Project	IEEE 802.16 Broadband Wireless Access Working Group < http://ieee802.org/16 >	
Title	Improved Data and Pilot Allocation for Cellular OFDMA Systems with Multiple Antennas	
Date Submitted	2004-07-08	
Source(s)	Wonil Roh, JeongTae Oh, Chan-Byoung Chae, Kyunbyoung Ko, Hongsil Jeong, Sung-Ryul Yun, Seungjoo Maeng, Panyuh Joo, Jaeho Jeon, Jaeyeol Kim, Soonyoung Yoon	wonil.roh@samsung.com Voice: +82-31-279-3868
	Samsung Electronics Co., Ltd.	
	Wen Tong, Peiying Zhu, Jianglei Ma, Ming Jia	wentong@nortelnetworks.com Voice: +1-613-763-1315
	Nortel Networks	
	Erik Lindskog, Brett Schein, Kamlesh Rath, K. Giridhar, Aditya Agrawal, David Garrett, B. Sundar Rajan, A. Paulraj	elindskog@beceem.com Voice: +1-408-387-5014
	Beceem Communications, Inc.	
Re:	Contribution supporting TGe WG ballot #14b	
Abstract	Improved Data and Pilot Allocation for Cellular OFDMA Systems with Multiple Antennas	
Purpose	Adoption of proposed changes into P802.16e Crossed out indicates deleted text , <u>underlined blue indicates new text change to the Standard</u> , and <u>underlined green indicates newly added text from the original contribution</u>

Improved Data and Pilot Allocation for Cellular OFDMA Systems w

[Figure bbb - Pilot allocation for 2-antenna BS for the optional FUSC and the optional AMC zones](#)

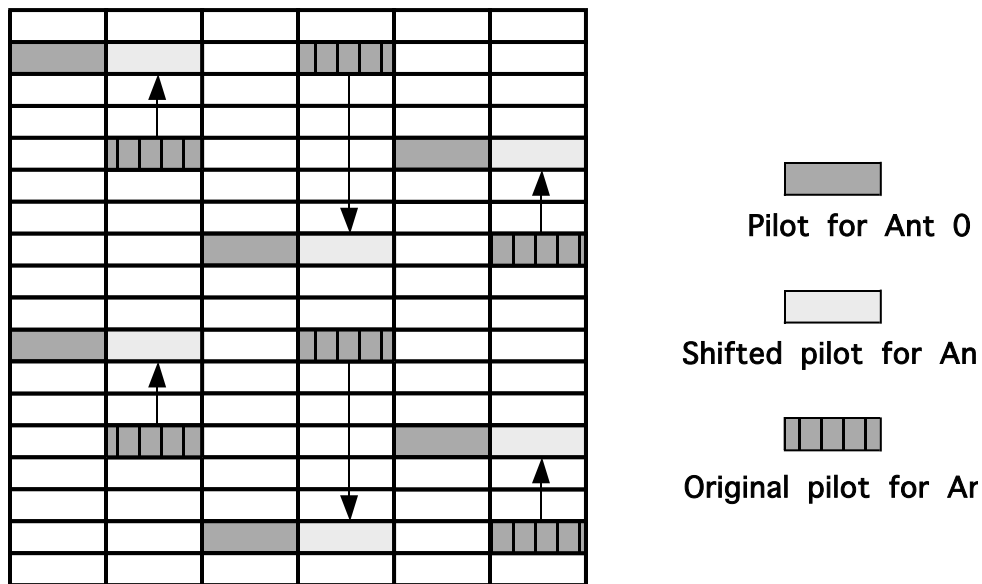
[For 2-antenna BS, all pilots in the even symbols shall be allocated for antenna 0 whereas all pilots in the odd symbols shall be allocated for antenna 1. The positions of pilots in the odd symbols are further switched with those of data subcarriers whose locations coincide with pilots in the previous symbol. This is shown in Figure bbb.](#)

Figure ccc - Pilot allocation for 4-antenna BS for the optional FUSC and the optional AMC zones

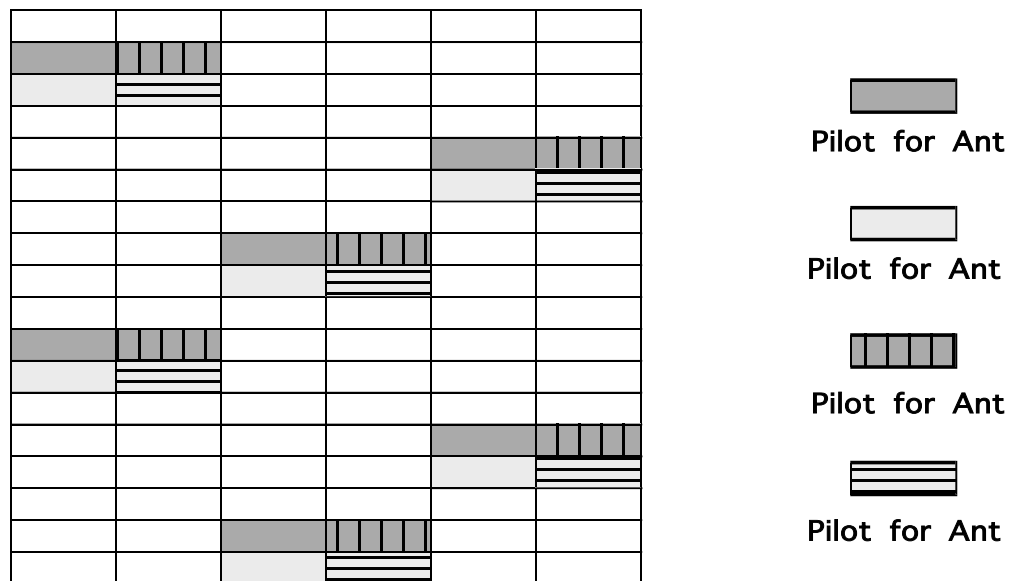
[For 4-antenna BS with more than 2 antennas, pilot pattern shall first be changed as in the 2-antenna BS case, and then the neighboring two subcarriers shall be further punctured-allocated to pilots for other antennas, 2 and 3 as is shown in Figure ccc shows the pilot allocation scheme for 4-antenna BS.](#)

Figure ddd - Uplink pilot allocation for 2-antenna SS for the optional PUSC zones

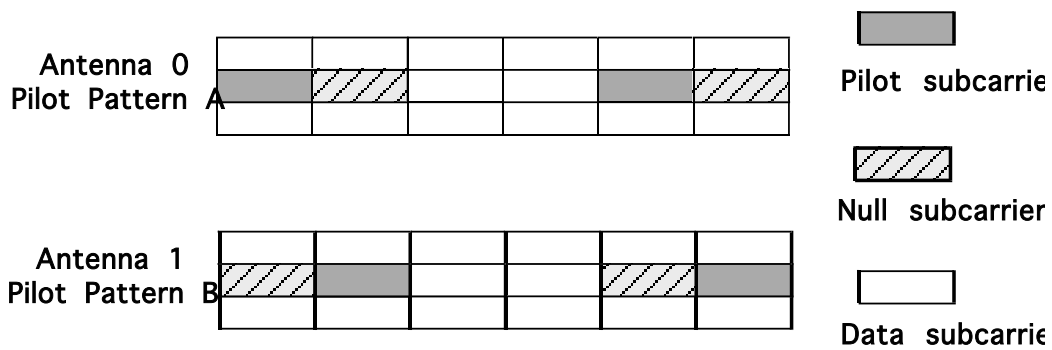
For 2-antenna SS and the optional PUSC, pilots for each antenna shall be allocated as shown in Figure ddd.

Figure eee - Uplink pilot allocation for 2-antenna SS for the optional AMC zones

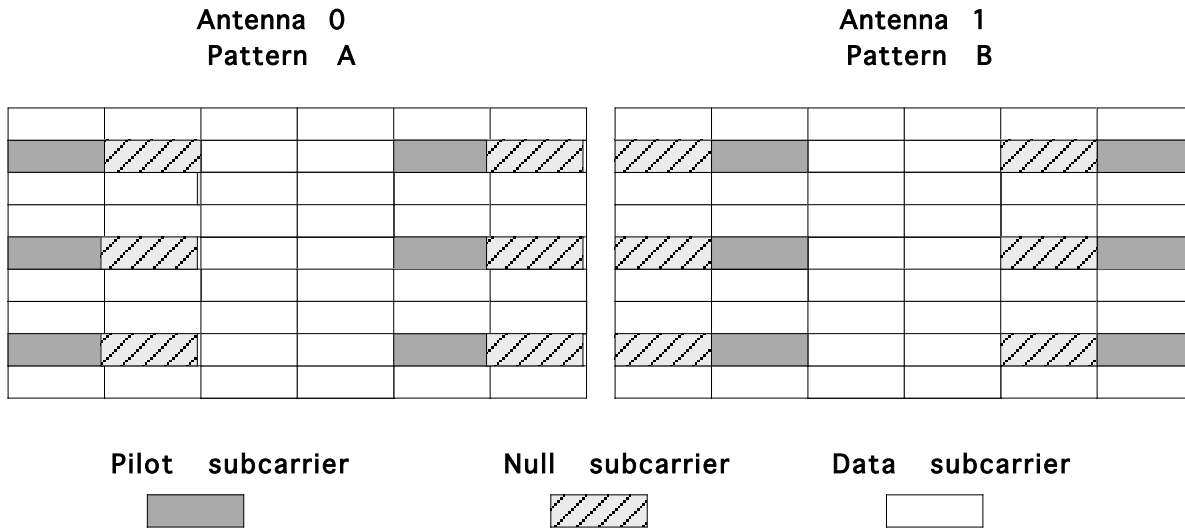
~~For 2-antenna BS and the optional AMC, all pilots in the 1st, 2nd, 5th and 6th symbols shall be allocated for antenna 0, 1. This is shown in Figure eee.~~

For 2-antenna SS and the optional AMC, all pilots in the 1st, 5th symbols shall be allocated for antenna 0, while pilots in the 2nd and 6th symbols shall be allocated for antenna 1. This is shown in Figure eee.
